Addendum #1

Project Number: 20241267

Project Name: BL237 Wright Quad Construction New Activity Space

**PEDESTRIAN MAINTENANCE
OF TRAFFIC PLAN**

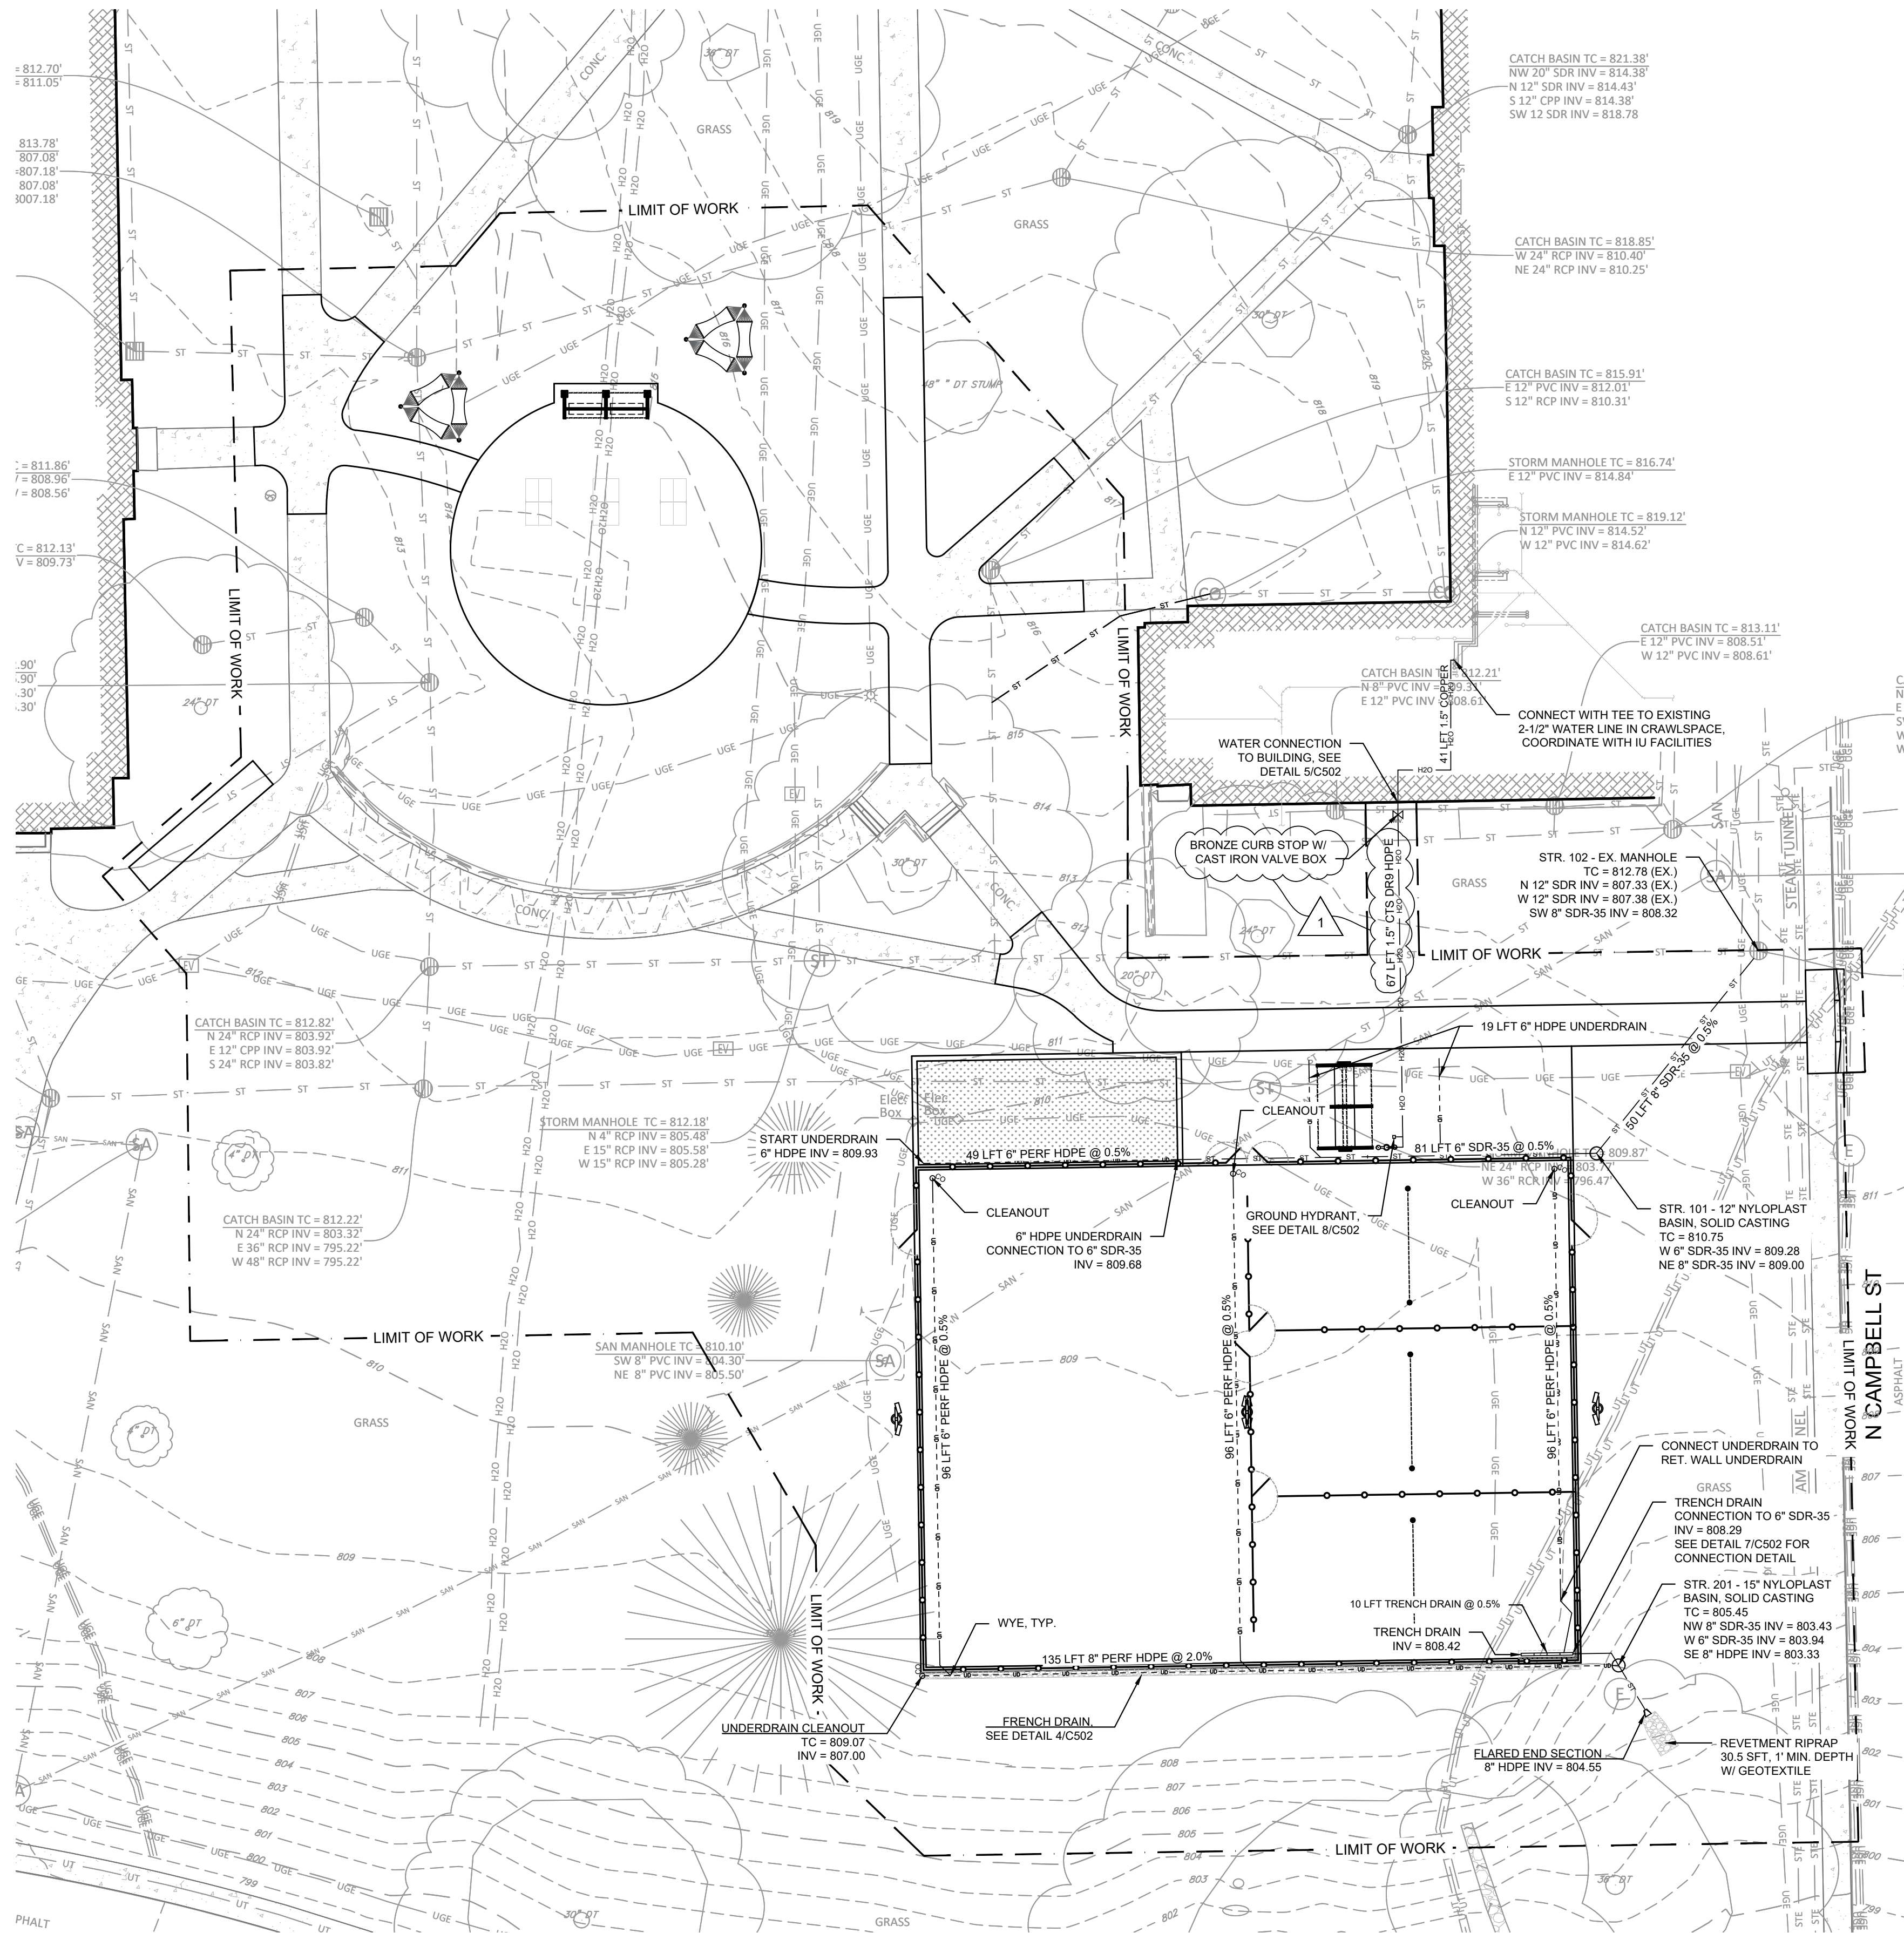
Item #1: G100 – Maintenance of Traffic Plan
DELETE sheet G100 – Maintenance of Traffic Plan. INSERT attached Sheet G100.

SITE UTILITY & DRAINAGE PLAN

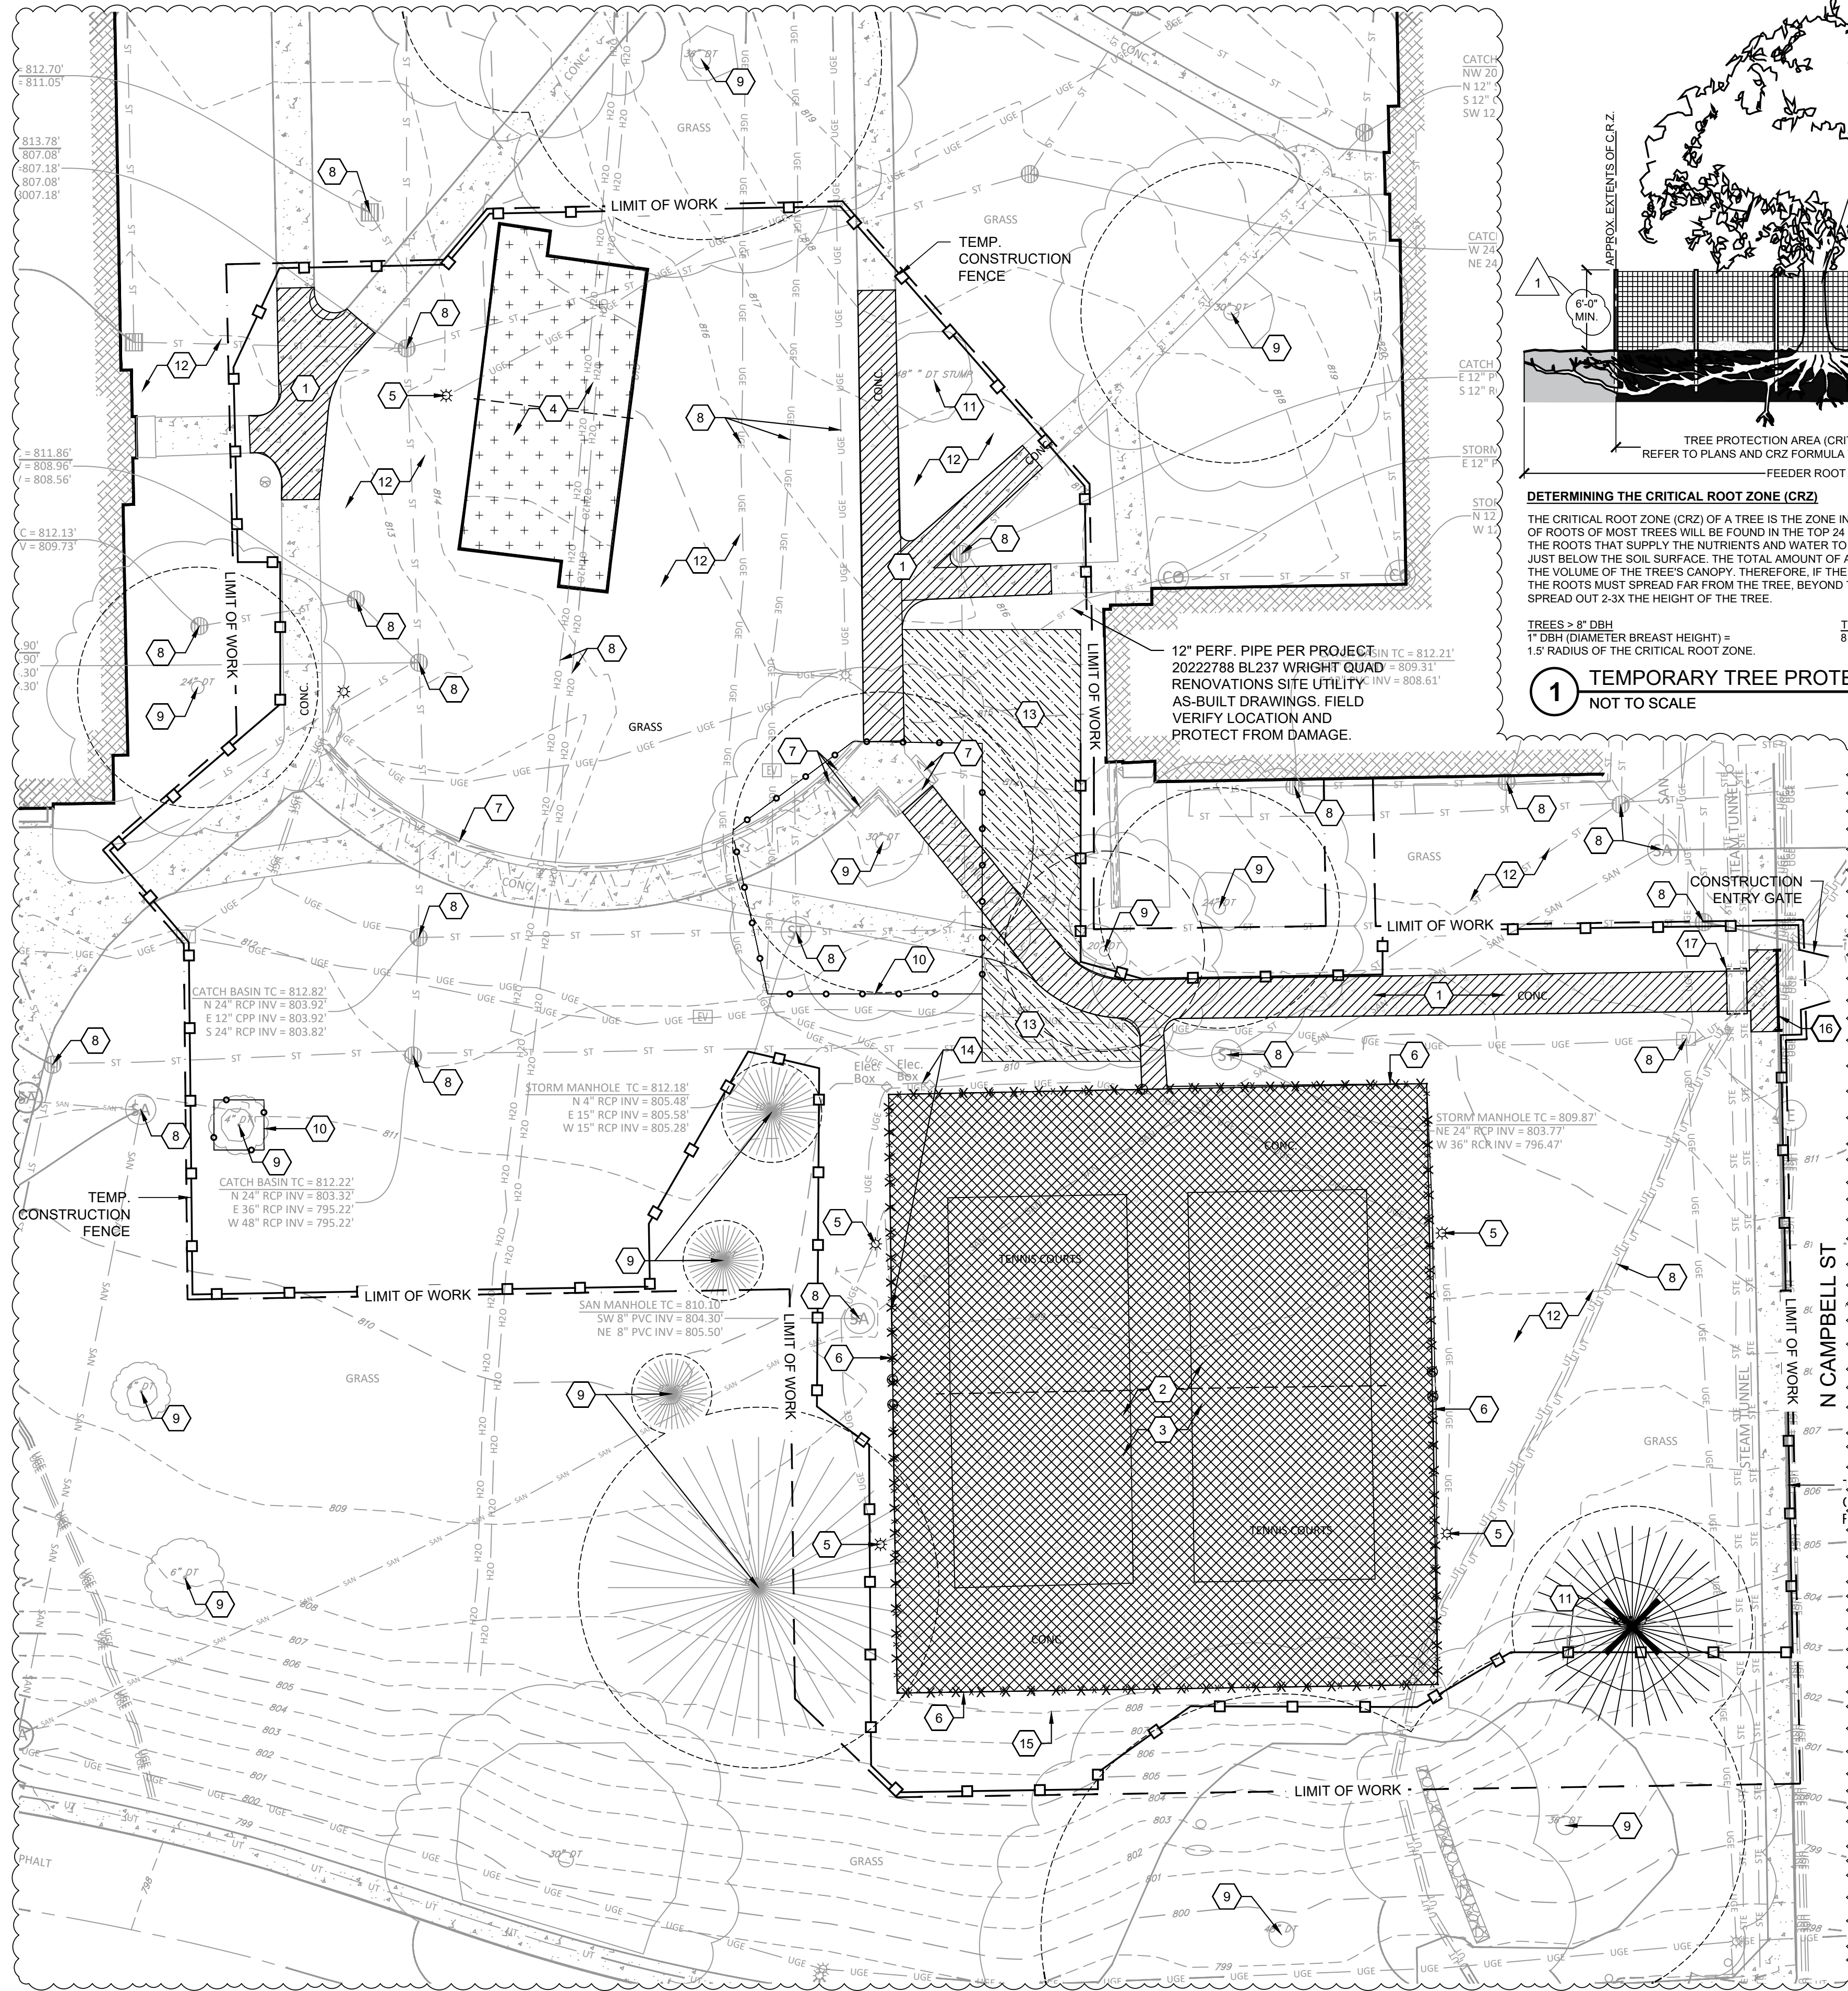
Item #2: C102 – Site Utility and Drainage Plan
DELETE sheet C102 – Site Utility and Drainage Plan. INSERT attached Sheet C102.
